Rezoning Transportation Analysis

Petition Number: 2022-210

From: Jake Carpenter, PE
Jacob.carpenter@charlottenc.gov
980-221-5675

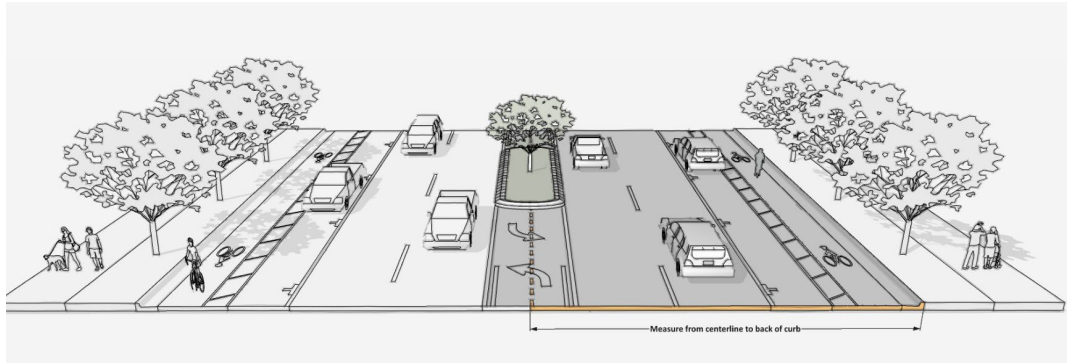
- a. ~~**South Tryon Street:** Location of curb and gutter to be moved a minimum of 42.5 feet from roadway centerline to accommodate the Charlotte Streets Map with a roadway typical section of a 4+ Avenue with Buffered/Separated Bike Lanes and On-Street Parking.~~

Outstanding Comment 9.20.23: Label and dimension the curb and gutter from the centerline for each road on the site plan.

Clarifying comment 6.21.23: Label and dimension the curb and gutter from the centerline for Clanton Road and South Tryon Street.

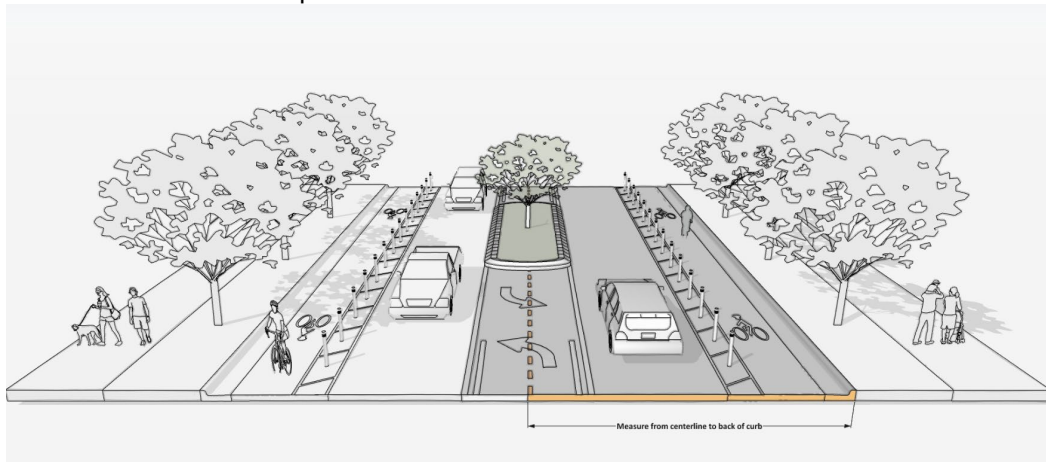
- b. ~~Clanton Road: Location of curb and gutter to be moved a minimum of 27 feet from roadway centerline to accommodate the Charlotte Streets Map with a roadway typical section of a 2+ Avenue with Buffered/Separated Bike Lanes.~~

NOTE: Additional distance from center line to back of curb may be required in locations where a median and turn lanes are required. Final curblines to be reviewed by CDOT once TIS is approved.
